Microcomputer Technical Information

| | | Document No. | | -CD-04-0077 | 1/2 |
| IE-78K0K1-ET In-Circuit Emulator for 78K0/KB1, KC1, KD1, KE1, KF1, KB1+, KC1+, KD1+, KE1+, KF1+ Usage Restrictions | | Date issued | September 28, 2004 Development Tool Group Multipurpose Microcomputer Systems Division 3rd Systems Operations Unit NEC Electronics Corporation | | |

Notes on Using IE-78K0K1-ET

No. 1 LED3 (POC RESET)

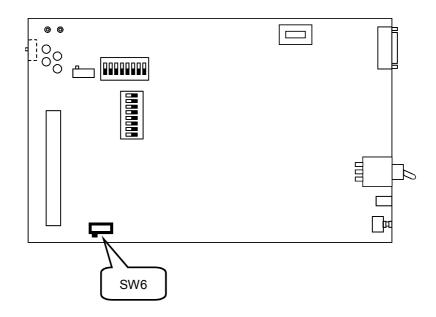
LED3 (POC RESET) is lit during the reset shown below. Do not perform a break when LED3 is lit; otherwise the integrated debugger ID78K0-NS will hang up.

• Internal reset by comparing the power supply voltage and detection voltage of the POC circuit
